April 13, 2018

Re: **Data Transmittal**

Clare Central Apartments
1003 and 1033 West Atkinson Avenue
Milwaukee, Wisconsin
Terracon Project No. 58107058A
WDNR BRRTS #02-41-549867
VPLE BRRTS #06-41-560680

SUB-SLAB DEPRESSURIZATION SYSTEM & AMBIENT AIR SAMPLING LOCATIONS - 1003 BUILDING CLARE CENTRAL APARTMENTS 1003 WEST ATKINSON AVENUE MILWAUKEE
WISCONSIN

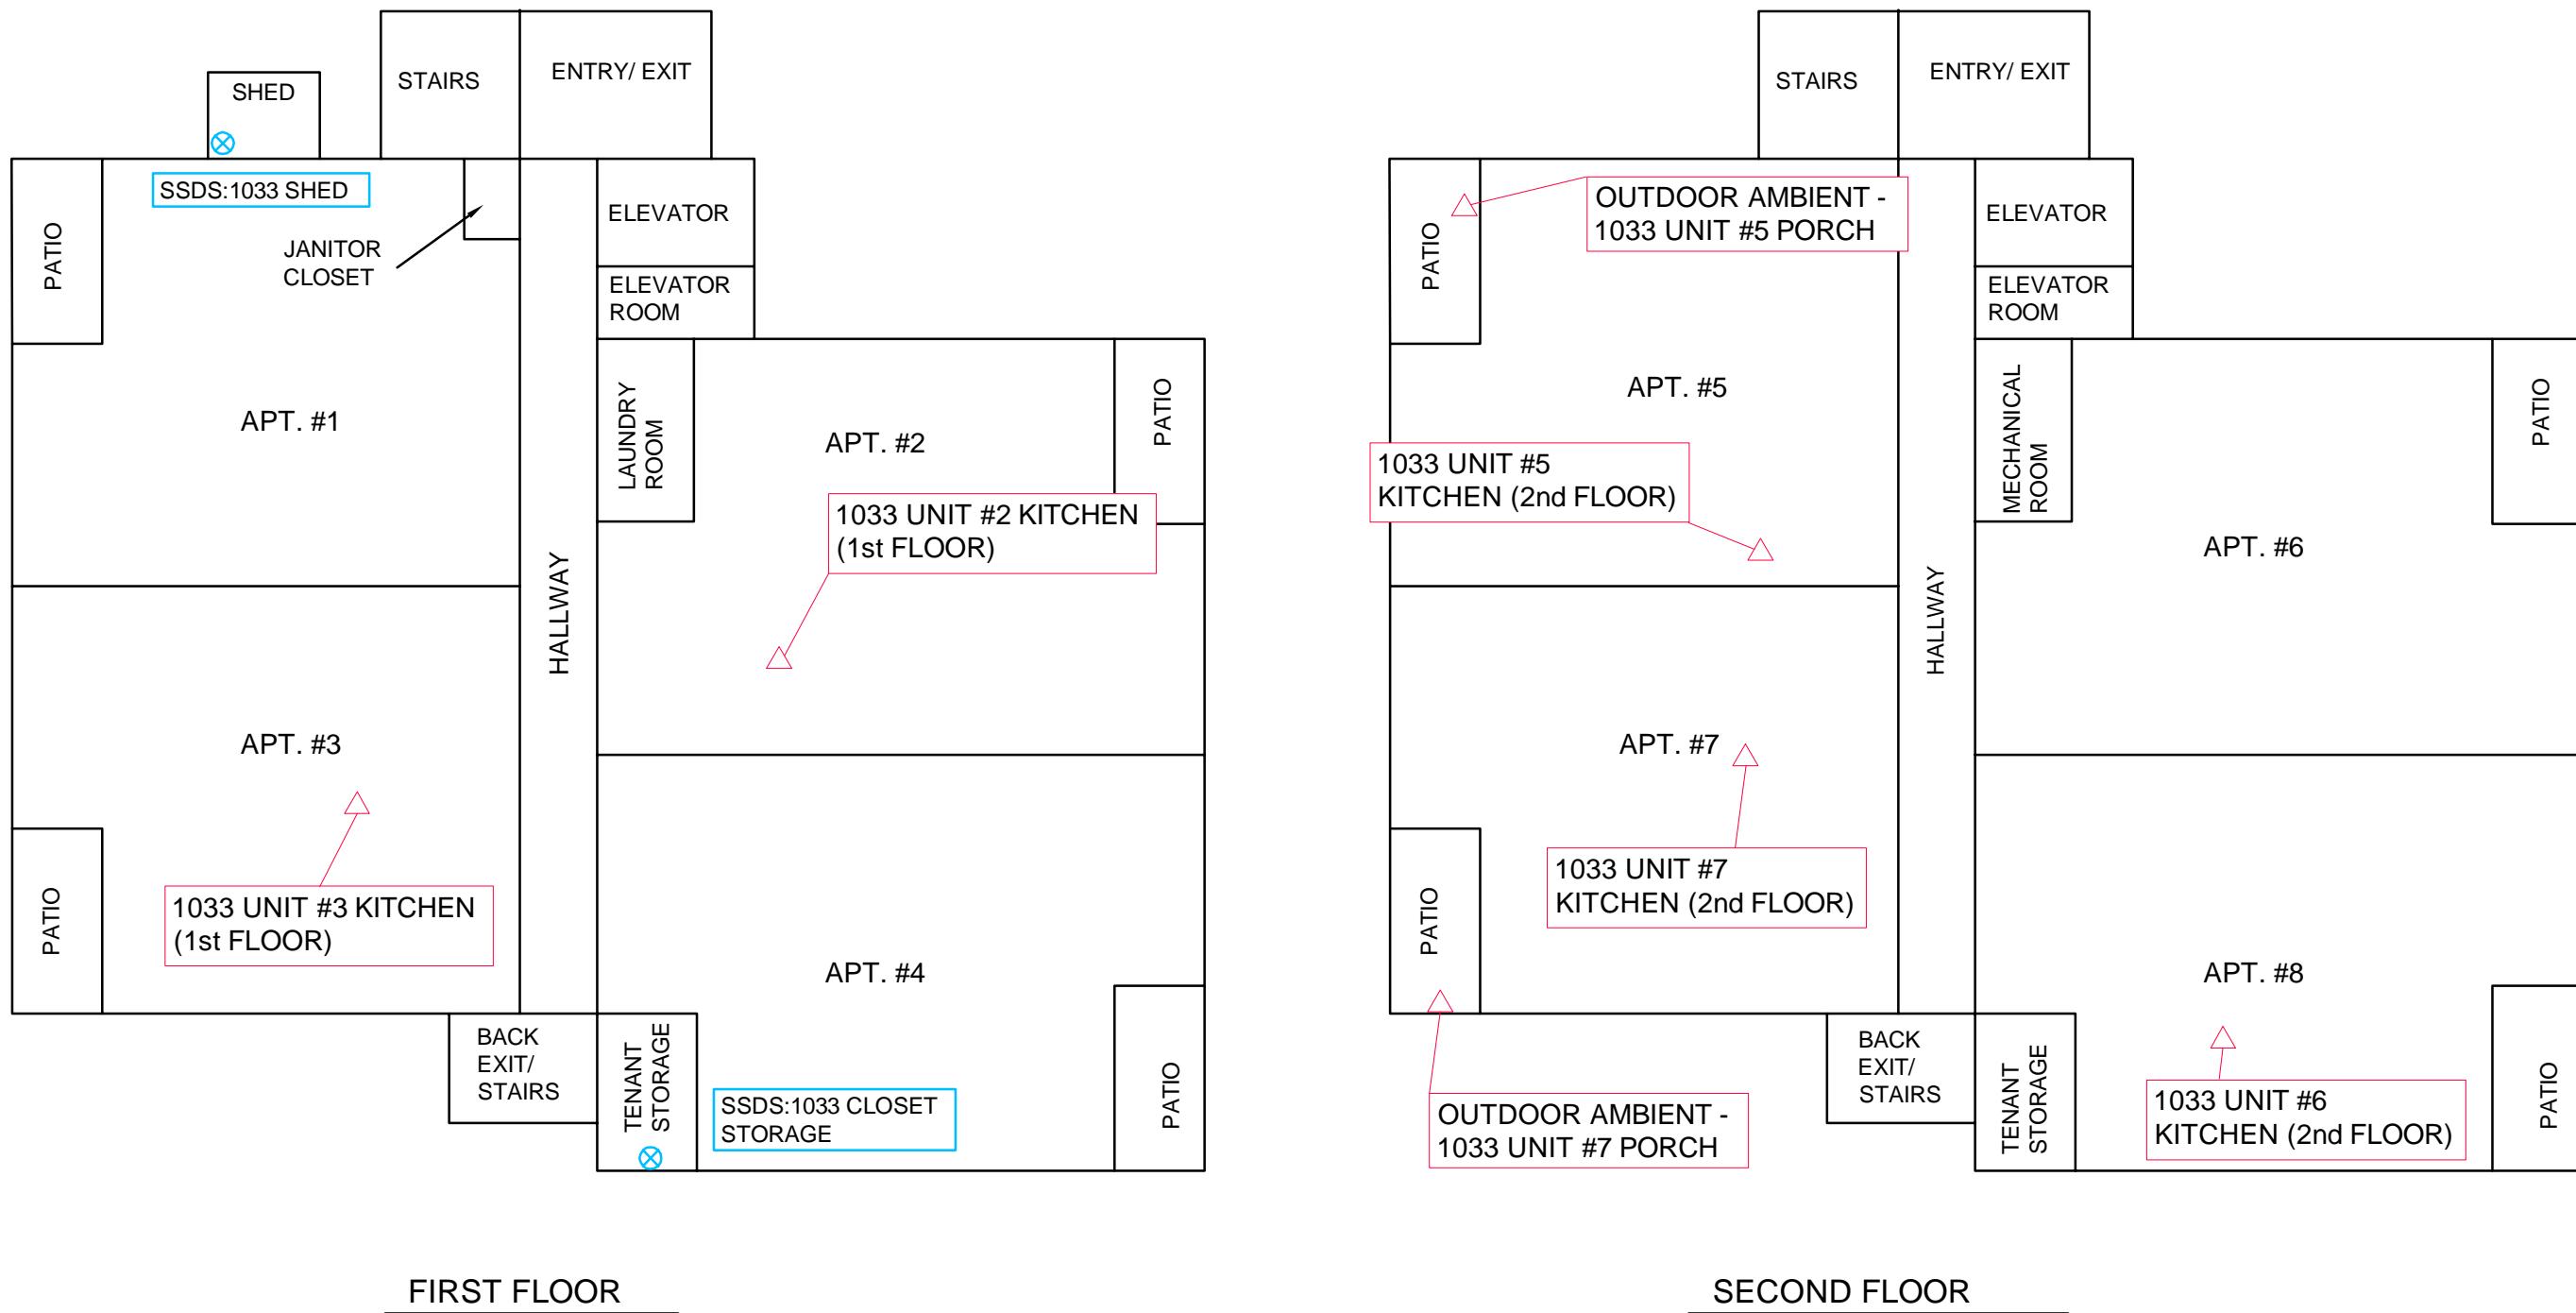
- “The DNR consulted with the Wisconsin Department of Health Services (DHS) regarding ambient air sampling results in the Clare Central Apartment buildings. Because there was a detection of trichloroethylene (2.0 ug/m³) just below the indoor air vapor action level (2.1 ug/m³) in one of the samples collected in the 1003 W. Atkinson Avenue building, the DNR is requesting that you have your consultant collect another round of ambient air samples from the 1003 building. The DNR is also asking for another round of ambient air samples in the 1033 building to ensure that two samples per floor are collected in each building as required in the DNR’s May 16, 2016 letter”.

On January 18, 2018, Terracon personnel collected ambient air samples from the Clare Central complexes. The 24-hour ambient air samples were collected in laboratory-prepared 6-liter Summa canisters with a flow regulator calibrated for 24-hour collection. The ambient air samples collected within the Summa canisters were submitted to the laboratory for analysis of tetrachloroethylene (PCE), TCE, trans-dichloroethylene (DCE), cis-DCE, and VC using EPA Method TO-15. CVOCs were not detected at concentrations above vapor action levels (VALs). Historical air analytical results are summarized on Table 4, and sampling location maps for the apartment complexes are presented on Exhibits 5 and 6.
